# HISTORIC AND DESIGN REVIEW COMMISSION

**HDRC CASE NO:** 2019-038  
**ADDRESS:** 432 W MARKET ST  
**LEGAL DESCRIPTION:** NCB 107 BLK LOT 13 SAN ANTONIO DRUG CO SUBD  
**ZONING:** D,HS  
**CITY COUNCIL DIST.:** 1  
**LANDMARK:** San Antonio Drug Company  
**APPLICANT:** Mariano Martino/City of San Antonio  
**OWNER:** City of San Antonio  
**TYPE OF WORK:** Installation of sidewalk art panels  
**APPLICATION RECEIVED:** January 18, 2019  
**60-DAY REVIEW:** March 19, 2019  
**REQUEST:**

The applicant is requesting a Certificate of Appropriateness for approval to install three sidewalk art panels in the right-of-way adjacent to the structure located at 432 W Market St.

**TO:** Theresa Larson, Environmental Services Coordinator, TCI, EMD  
**FROM:** Miranda Garrison, Architectural Historian, TCI, EMD  
**COPIES TO:** Files  
**SUBJECT:** **District One Pedestrian Mobility – Sidewalk Vault Lights (432 Market Street)**  
**DATE:** January 11, 2019

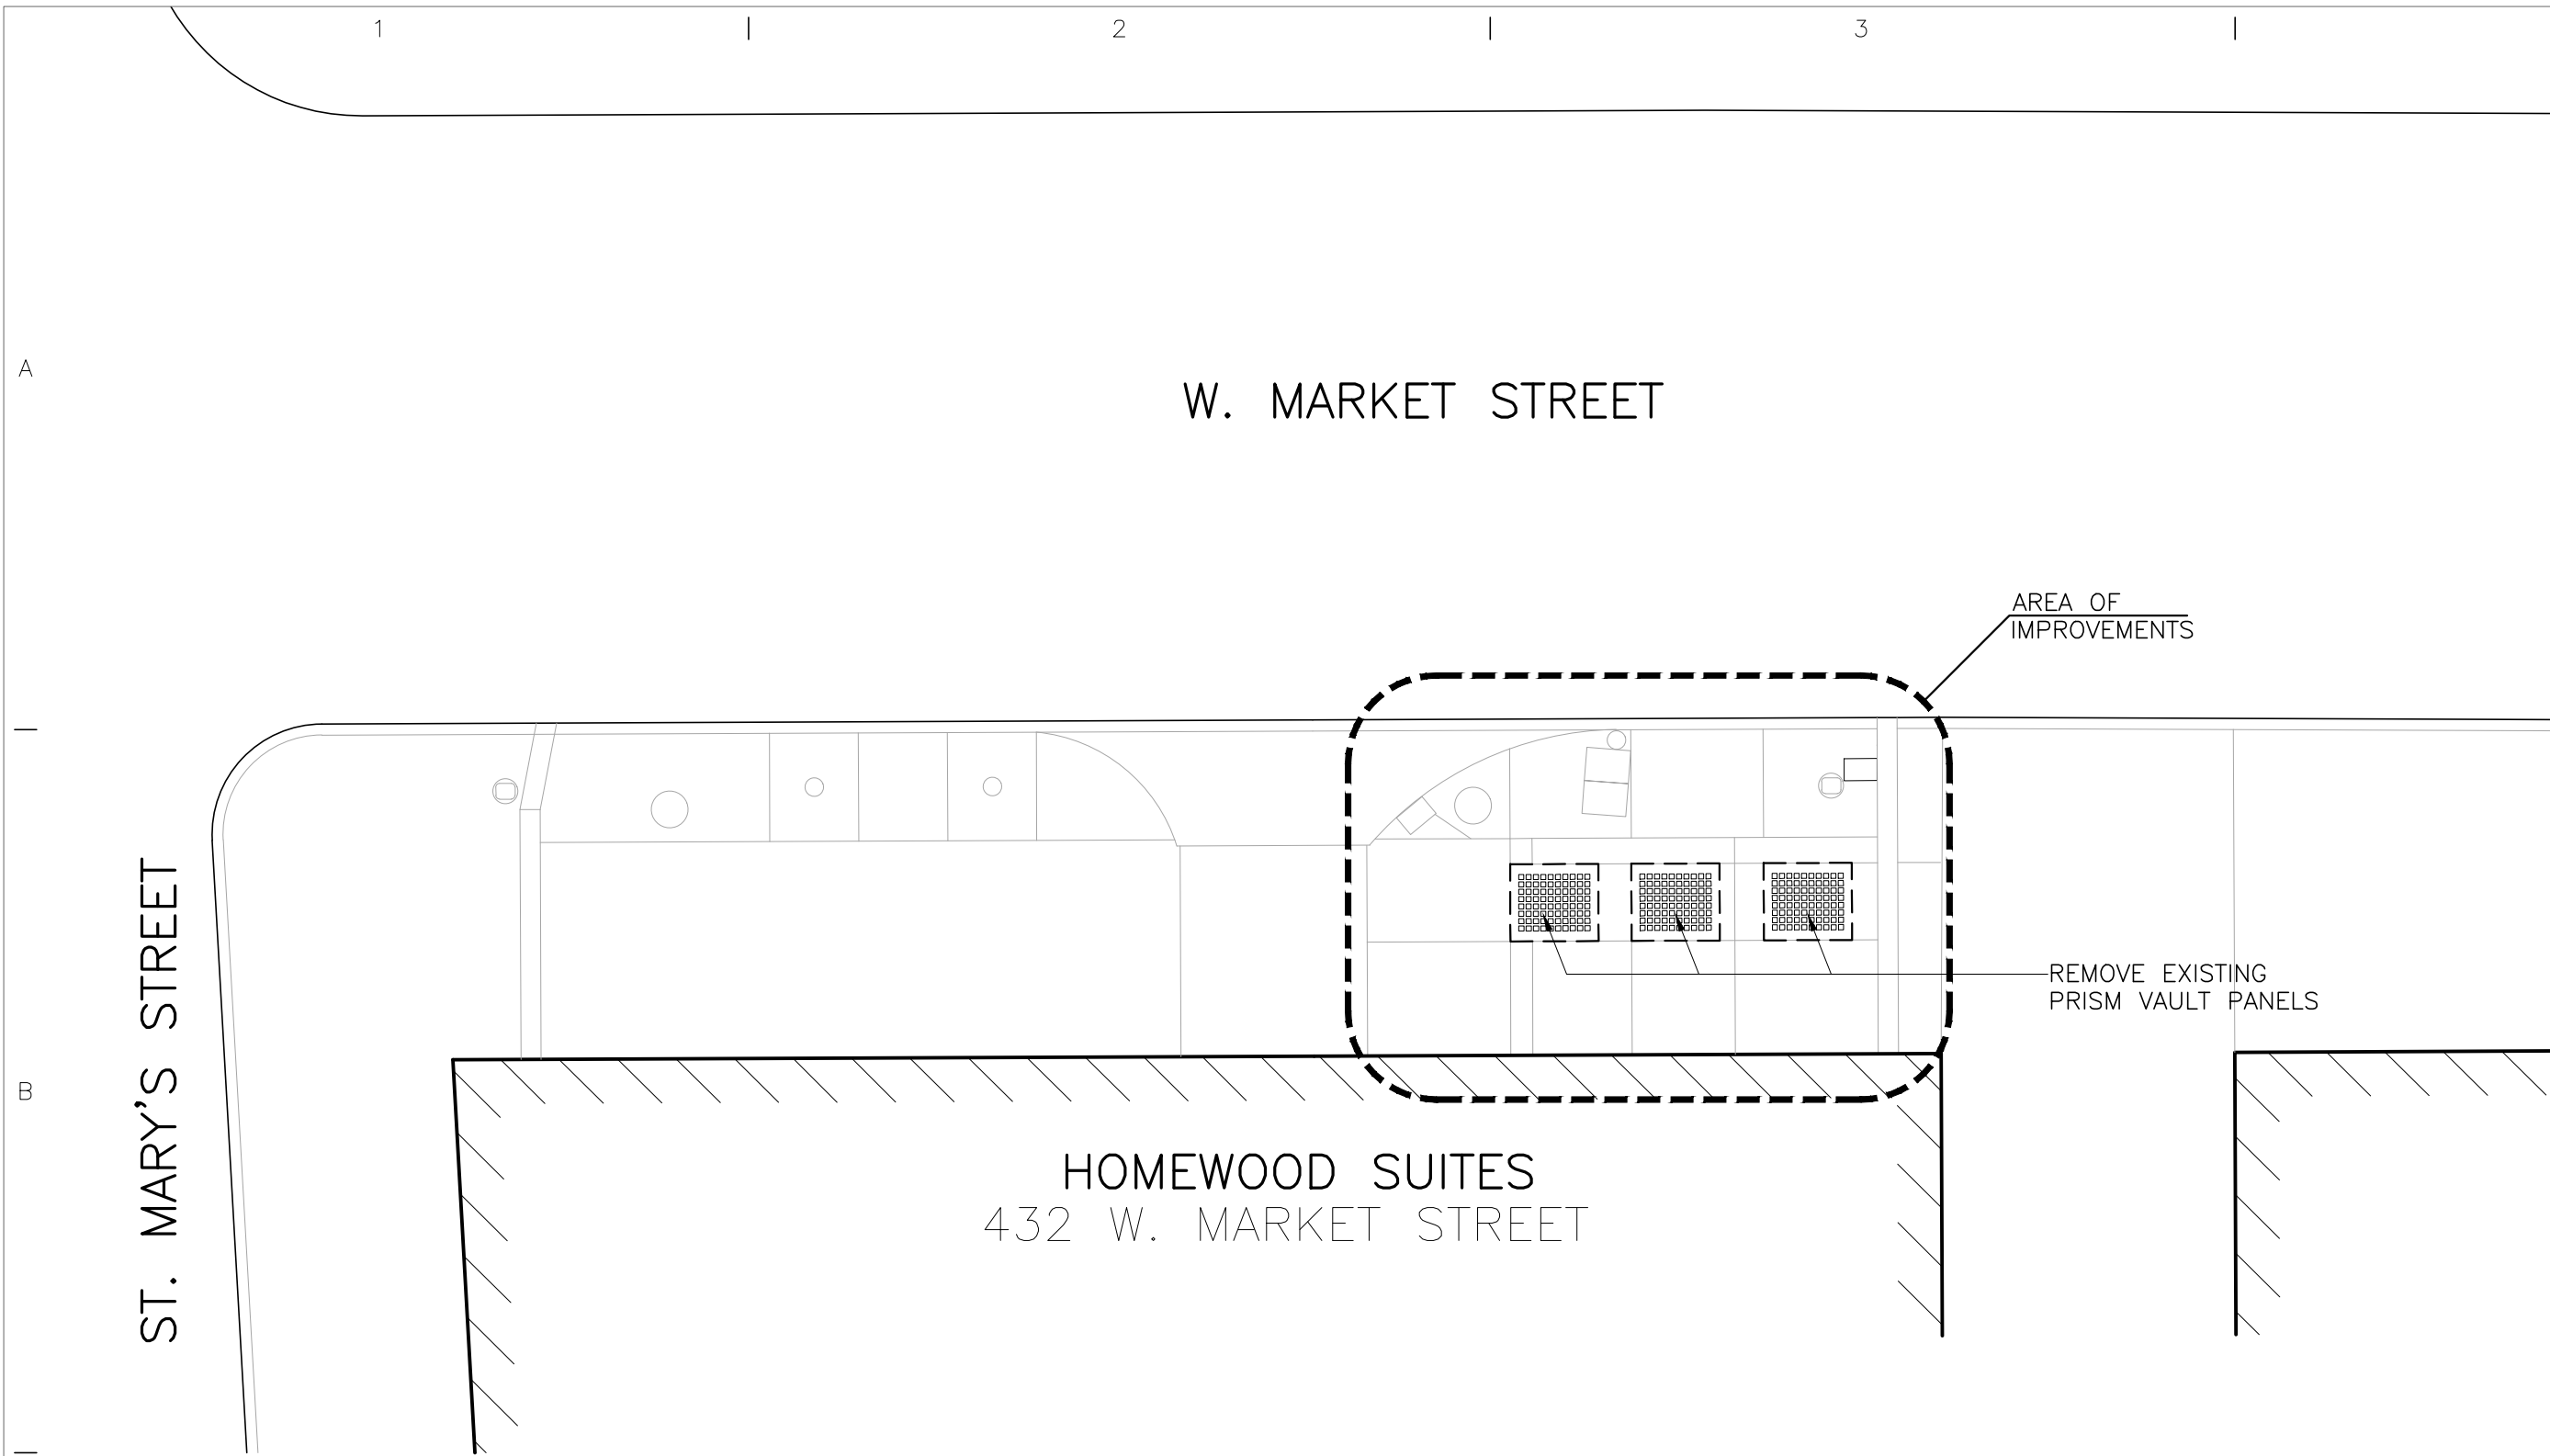
Unfortunately, the vault lights located at 432 Market Street have been irreversibly damaged over time to the point that they no longer maintain their integrity. Please see attached photographs. Most of the glass has been removed and replaced with concrete, and those that do remain are cracked and shattered. If they were to be replaced, the panels and the prism glass would have to be of new construction. Also, many panels along the sidewalk lining the structure have already been replaced with concrete, further diminishing the relationship between the sidewalk vault lights and the building.

**In the opinion of the TCI EMD and based on the status of the three remaining sidewalk vault light panels, removing them will have no adverse effect to the San Antonio Drug Company Building.**
